Proposal #14: 6085-02-75, WISC 2024025 Mazomanie - Sun Prairie USH 151 Interchange STH 19 Dane County 6085-02-77, WISC 2023359 C Sun Prairie, Windsor Street N Thompson Rd Intr; Davison Dr Intr STH 19 Dane County

This is Addendum No. 01, which provides for the following:

ADDENDUM NO. 01

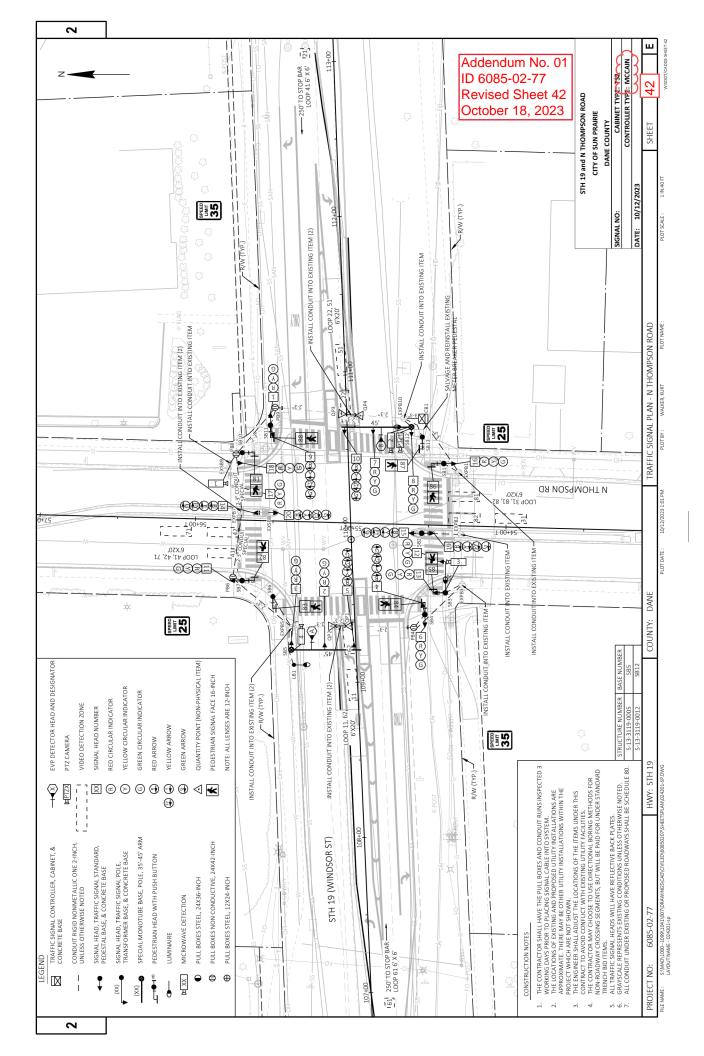
Revised Plan Sheets				
Plan Sheet	et Plan Sheet Title (brief description of changes to sheet)			
42	Traffic Signal Plan - N Thompson Road (Controller Type Change)			
43	Sequence of Operations - N Thompson Road (Controller Type Change)			
45 Traffic Signal Plan - Davison Drive (Controller Type Change)				
46	Sequence of Operations - Davison Drive (Controller Type Change)
